TM-F22-0008 SUMMER BROOK UNIT 1 FINAL MAP EXHIBIT A - ASSESSOR'S PARCEL MAP

TM-F22-0008 Exhibit F
Conditions of Approval Conformance Verification for Summer Brook Unit 1 Final Map

The following contains verification of conformance of the proposed Summer Brook Unit 1 Final Map with the approved Tentative Subdivision Map (TM-07-1440-R2) and applicable Conditions of Approval (COA).

TM-F22-0008 is the Final Map application for Phased Tentative Subdivision Map TM07-1440-R-2 (Summer Brook Unit 1, Phases 1 & 2). The below COA were reviewed and approved by the Planning Commission in 2018.

cta Engineering & Surveying
 SHEET 9 OF 9

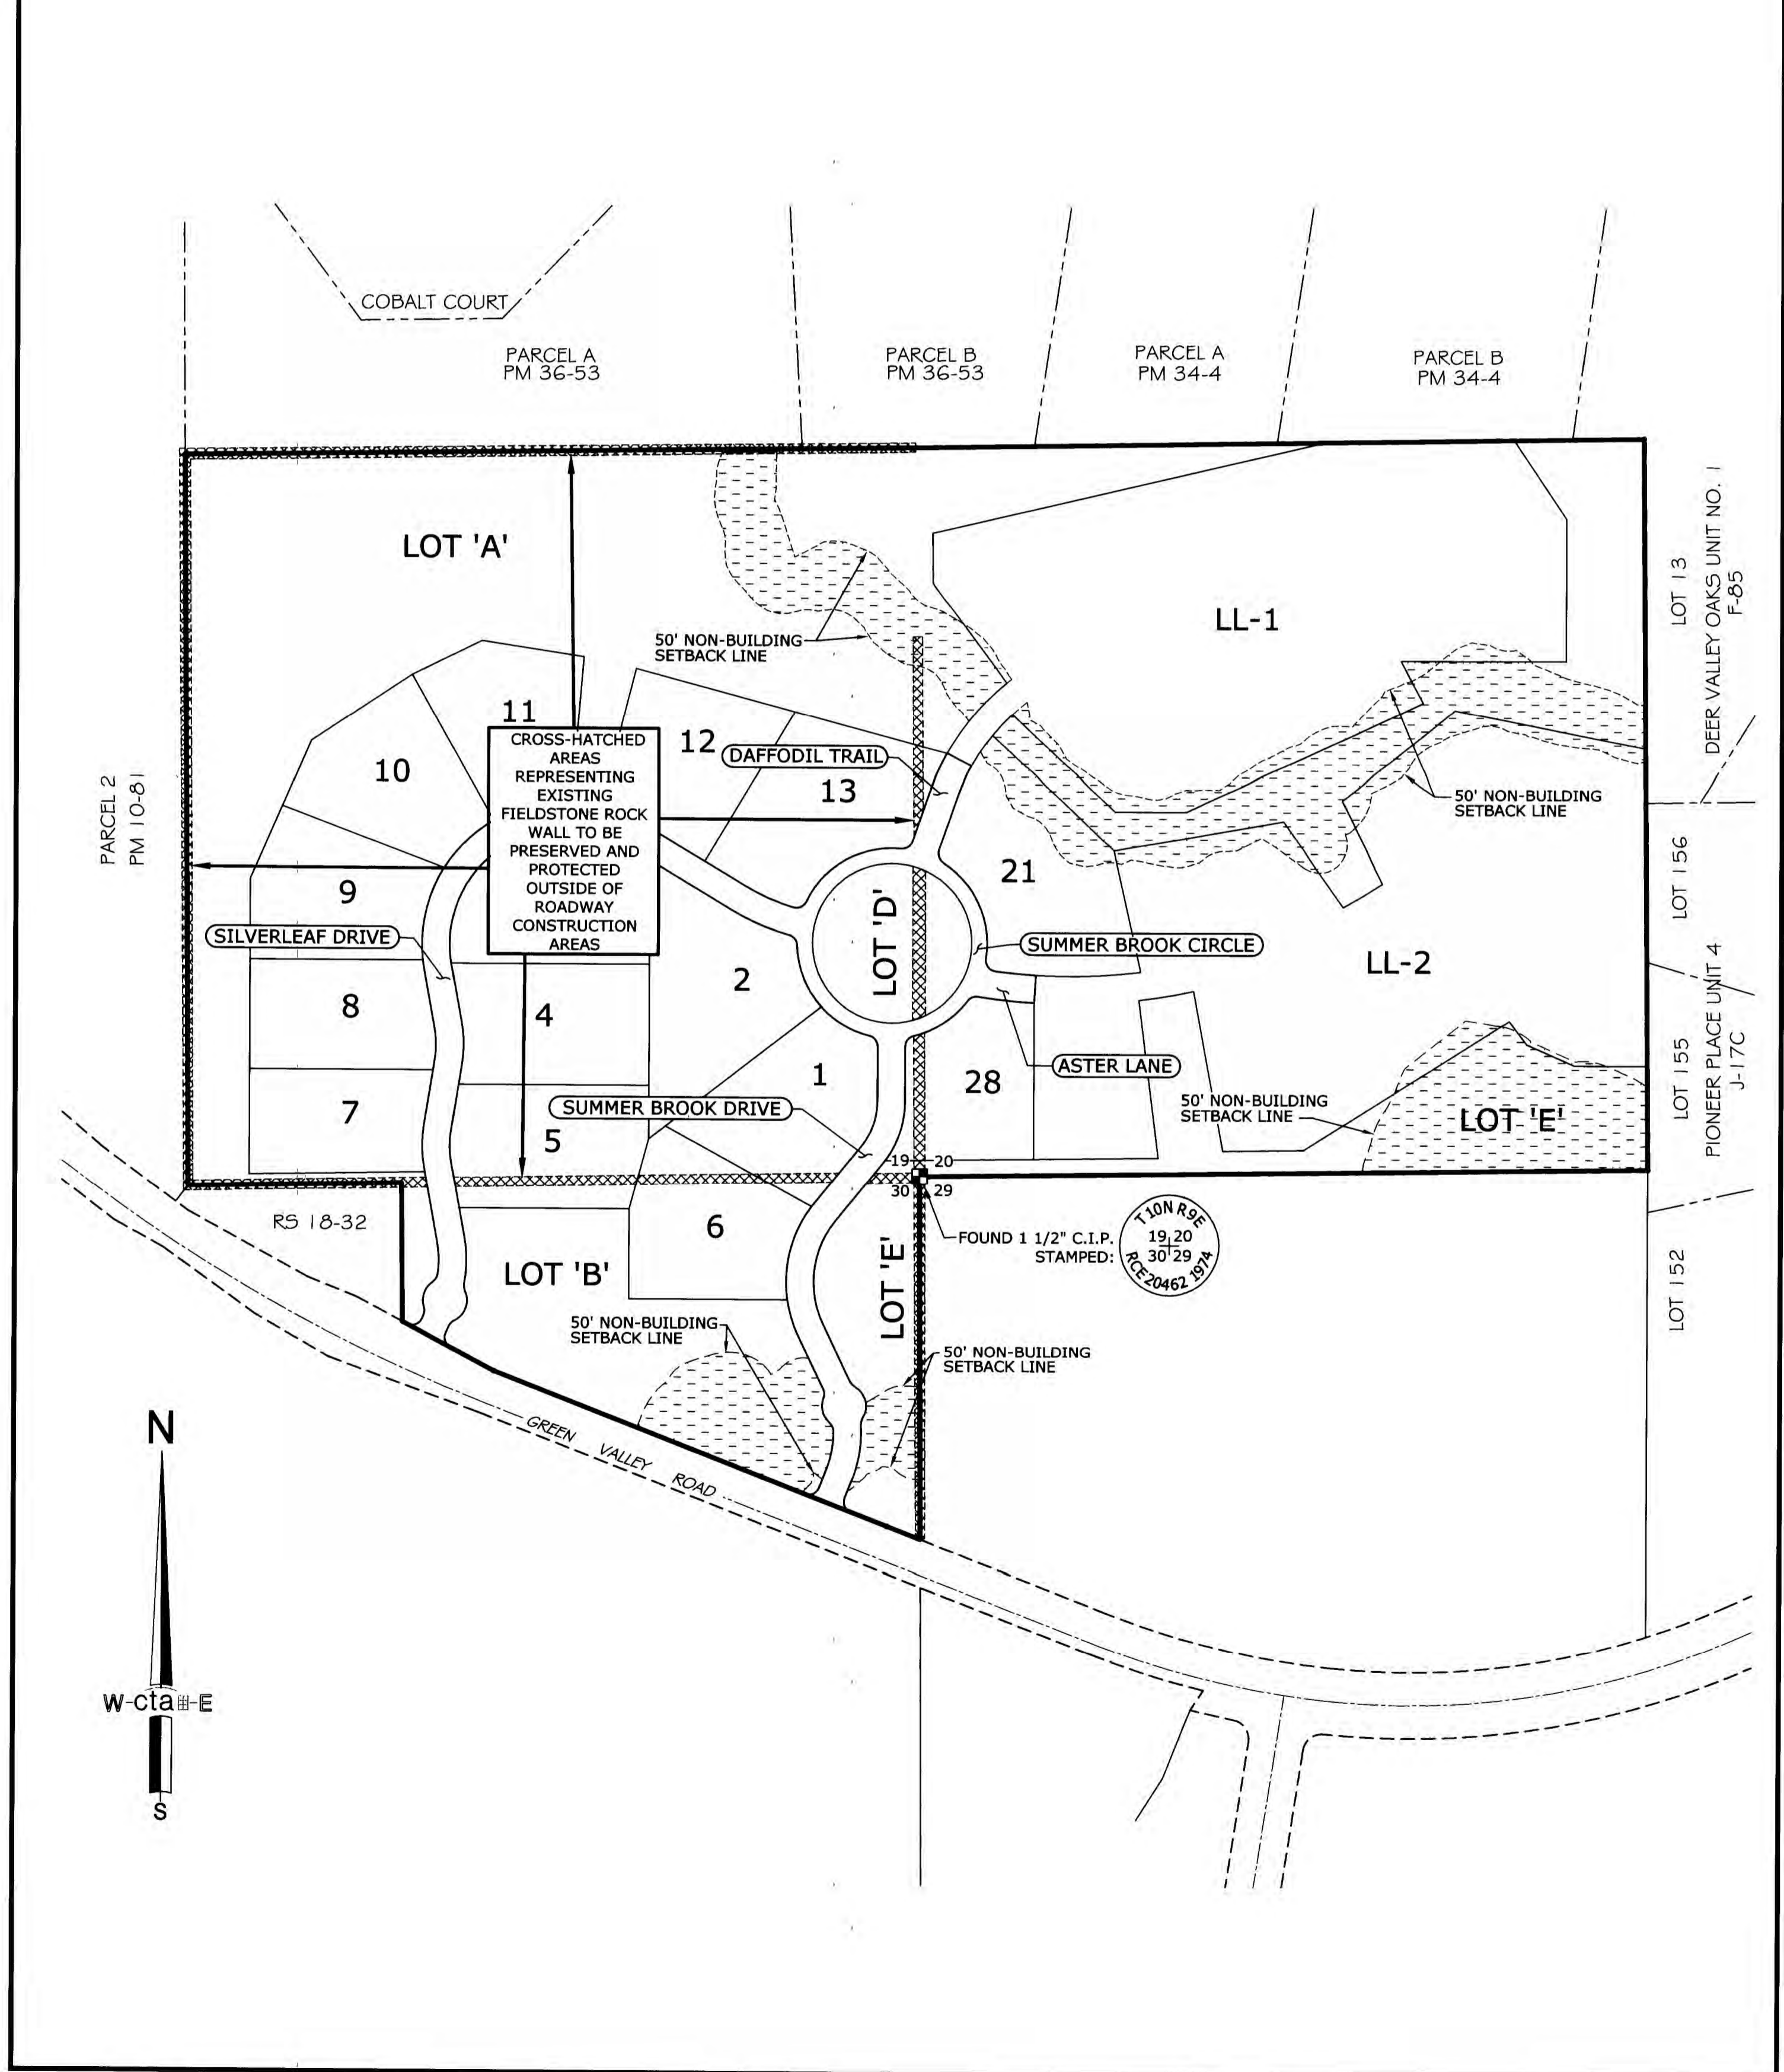
of road construction. The rock wall shall be located within designated Conservation Easements and shall remain in perpetuity. Planning Services shall verify the placement of the Conservation Easements prior to filing the Final Map.

MONITORING: Planning Services shall review and approve the Conservation Easements prior to filing the Final Map.

13. The Final Map shall include a 100-ft non-building setback from all ponds and a 50-ft. non-building setback from all wetlands at the subject site as delineated on Exhibit F. Planning Services shall review and approve the setbacks prior to filing the Final Map.

Staff Verification: Condition Satisfied. The Final Map Informational Sheet (Sheet 9 of 9) shows all portions of the dry-laid fieldstone rock wall to be preserved consistent with this condition. This informational sheet also documents the locations of conservation easements to be recorded with the Final Map to preserve these features in perpetuity.

Staff Verification: Planning Services verified Non-building setbacks are shown on the Informational Sheet of the Final Map as required. Therefore, the project is consistent with this condition.
